STATE OF NEVADA
Department of Conservation & Natural Resources
DIVISION OF ENVIRONMENTAL PROTECTION

Re: **Tronox LLC (TRX)**
NDEP Facility ID #H-000539
Nevada Division of Environmental Protection (NDEP) Response to:
*Revised Excavation Plan for Phase B Soil Remediation of RZ-D, Addendum to the
Removal Action Work Plan, Tronox LLC, Henderson, Nevada*
Dated: August 31, 2010

Attachment A

Figure C-3

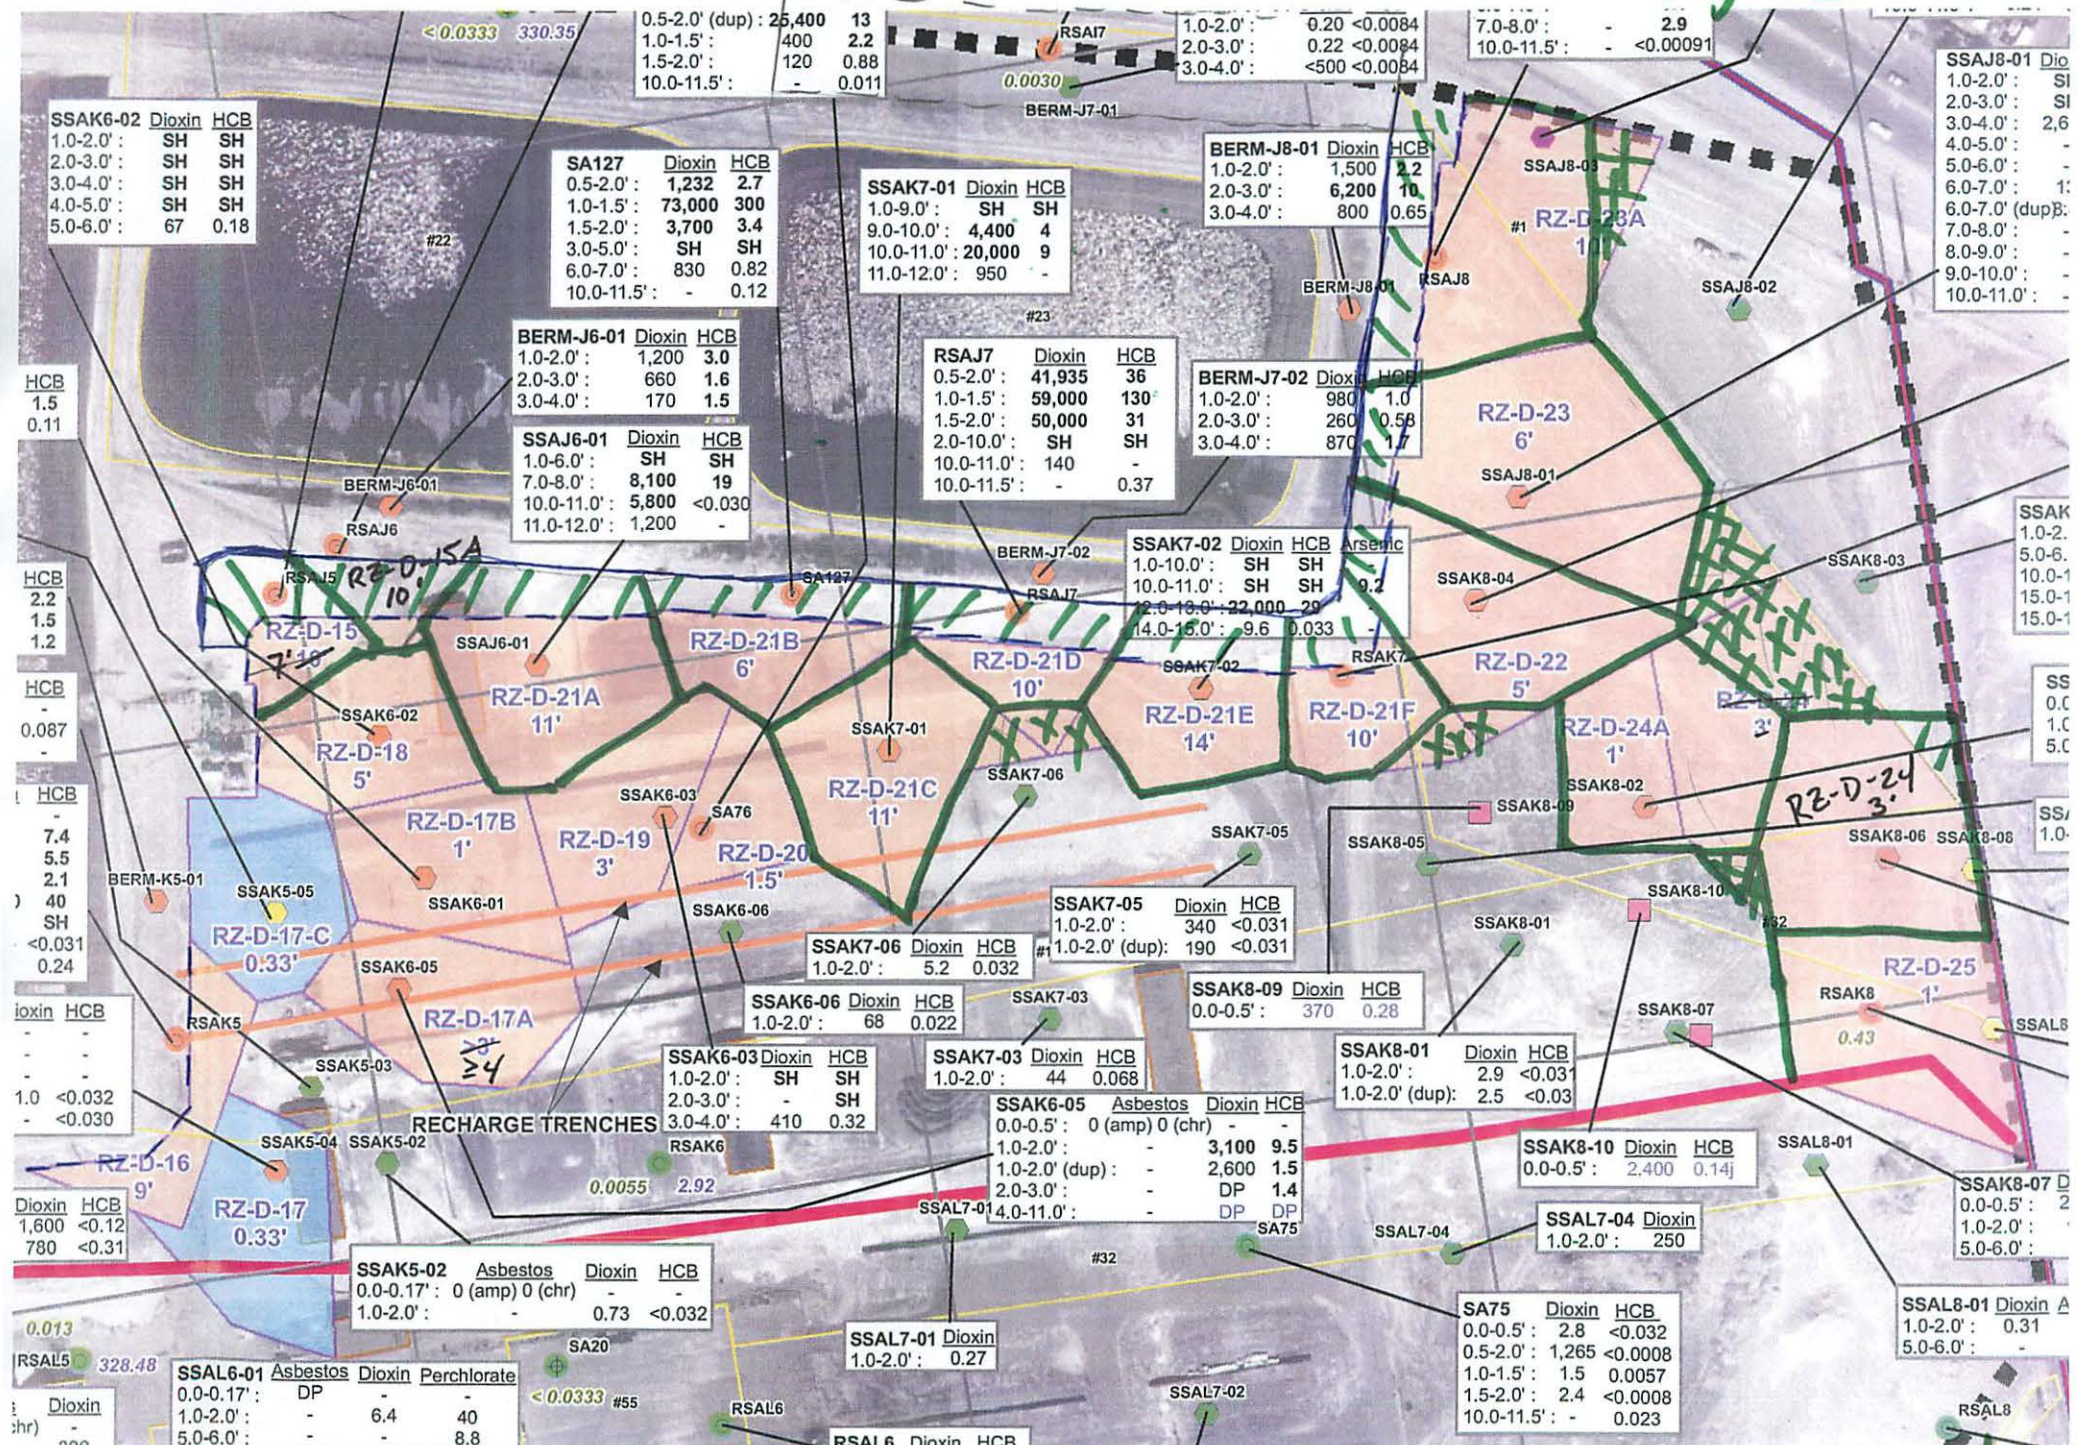
Excavation Area	Contaminated Sampling Location	Adjacent Sampling Locations	Depth fbgs	Exceptions
RZ-D-21A (C-3)	SSAJ6-01	SSAK6-02 SSAK6-01 SSAK6-03 SA127	11	Northern cutline: toe of WC-West pond berm (or approved setback)
RZ-D-21B (C-3)	SA127	SSAJ6-01 SSAK6-03 SA76 SSAK7-01 RSAJ7	6	Northern cutline: toe of WC-West and WC-East pond berms(or approved setback)
RZ-D-21C (C-3)	SSAK7-01	SA127 SA76 SSAK6-06 SSAK7-06 RSAJ7	11	
RZ-D-21D (C-3)	RSAJ7	SA127 SSAK7-01 SSAK7-06 SSAK7-02	10	Northern cutline: toe of WC-East pond berm (or approved setback)
RZ-D-21E (C-3)	SSAK7-02	RSAJ7 SSAK7-06 SSAK7-05 RSAK7	14	Northern cutline: toe of WC-East pond berm (or approved setback)
RZ-D-21F (C-3)	RSK7	SSAK7-02 SSAK7-05 SSAK8-05 SSAK8-09 SSAK8-04	10	Northwestern cutline: toe of WC-East pond berm (or approved setback)
RZ-D-22 (C-3)	SSAK8-04	RSK7 SSAK8-09 SSAK8-02 SSAJ8-01	5	Western cutline: toe of WC-East pond berm (or approved setback)

RZ-D-23 (C-3)	SSAJ8-01	SSAK8-04 RSAJ8 SSAJ8-02 SSAK8-03	6	Western cutline: toe of WC-East pond berm (or approved setback)
RZ-D-23A (C-3)	RSAJ8	SSAJ8-01 SSAJ8-02	10	Western cutline: toe of WC-East pond berm (or approved setback) Northern cutline: property boundary with Parcel C

Excavation Area	Contaminated Sampling Location	Adjacent Sampling Locations	Depth fbgs	Exceptions
RZ-D-24 (C-3)	SSAK8-06	SSAK8-03 RSAK8 SSAK8-10 SSAK8-02	3	Eastern cutline: eastern property boundary
RZ-D-24A (C-3)	SSAK8-02	SSAK8-04 SSAK8-03 SSAK8-06 SSAK8-10 SSAK8-09	1	
RZ-D-25	RSAK8	SSAK8-10 SSAK8-06 SSAL8-01	1	Eastern cutline: eastern property
RZ-D-26 (C-2)	SA173	SA189 SA123 SSAL5-01	0.33	Northern cutline: Groundwater treatment system area
	SA19	SA179 SSAL5-07		
RZ-D-26A (C-2)	SA189	SSAL4-03 SSAL4-02 SSAL5-01 SA173 SA123 SSAM4-01	0.5	No surface sample for dioxins/furans TEQ was collected per the NDEP-approved surface sampling protocol established by TRX. Therefore, the depth of this polygon is based on the 0.5-2 fbgs sample as it is less than the modified dioxins/furans TEQ BCL.
RZ-D-27 (C-2)	SSAM4-01	SSAL4-03 SA189 SA70 SSAM4-03 SSAM4-04	0.66	Southern cutline: RZ-E cutline
RZ-D-28 (C-4)	SA72	SA167 SA20 SA73 RSAM6	≥0.66	**remediation alternatives will be investigated for perchlorate contamination Southern cutline: toe of AP-5 pond berm

Figure C-4

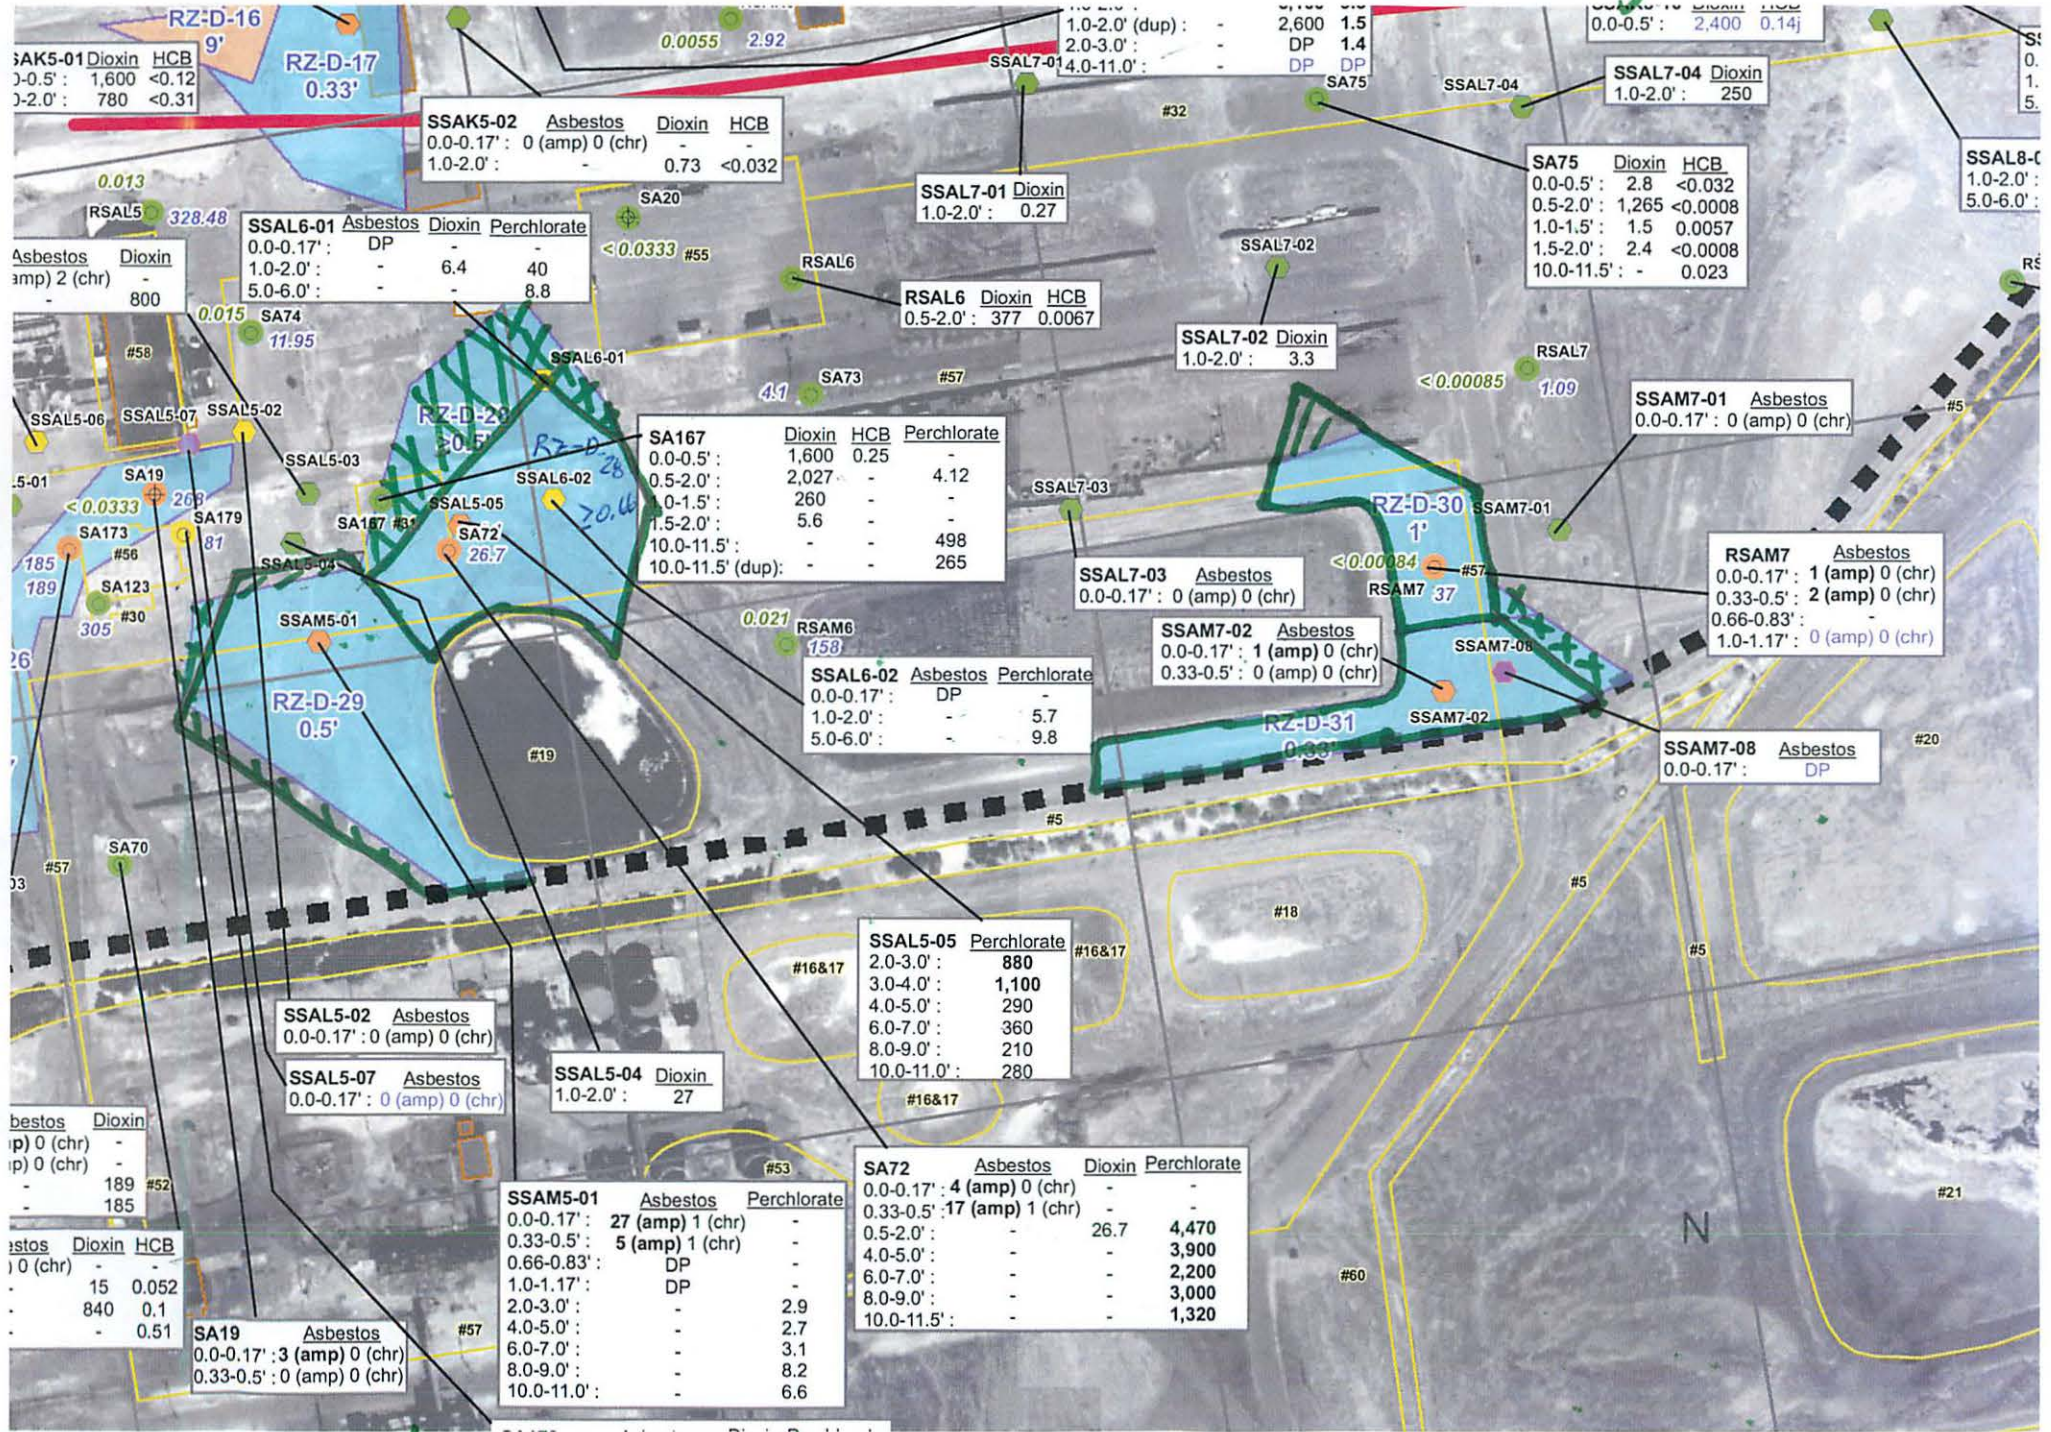
- e. RZ-D-28 / RZ-D-28A, TRX states that they have “elected to keep RZ-D-28 as one area”. Additionally, TRX states that this one area will be excavated to 10 fbgs. However, based on discussions on September 27, 2010 between NDEP and TRX and the September 27, 2010 Errata, NDEP understands that TRX will continue to investigate alternate remediation options for the perchlorate contaminated soils; therefore, TRX will excavate the asbestos contaminated soil and will recommend an alternative remedial method for the perchlorate-only contaminated soils. Please see Attachment B table and Figure C-4 for additional information.

RZ-D-29 (C-4)	SSAM5-01	SSAL5-03 SA167 SA72 SA70 SA123 SA179	≥0.66	Eastern cutline: toe of AP-5 pond berm

Excavation Area Name	Contaminated Sampling Location	Adjacent Sampling Locations	Depth fbg	Exceptions
RZ-D-30 (C-4)	RSAM7	SSAM7-02 SSAL7-03 RSAL7 SSAM7-01	1	Southern cutline: RZ-E cutline NDEP currently does not approve exclusion of the roadway from excavation.
RZ-D-31 (C-4)	SSAM7-02	RSAM6 RSAM7 SSAM7-01	0.33	Southern cutline: RZ-E cutline NDEP currently does not approve exclusion of the roadway from excavation.
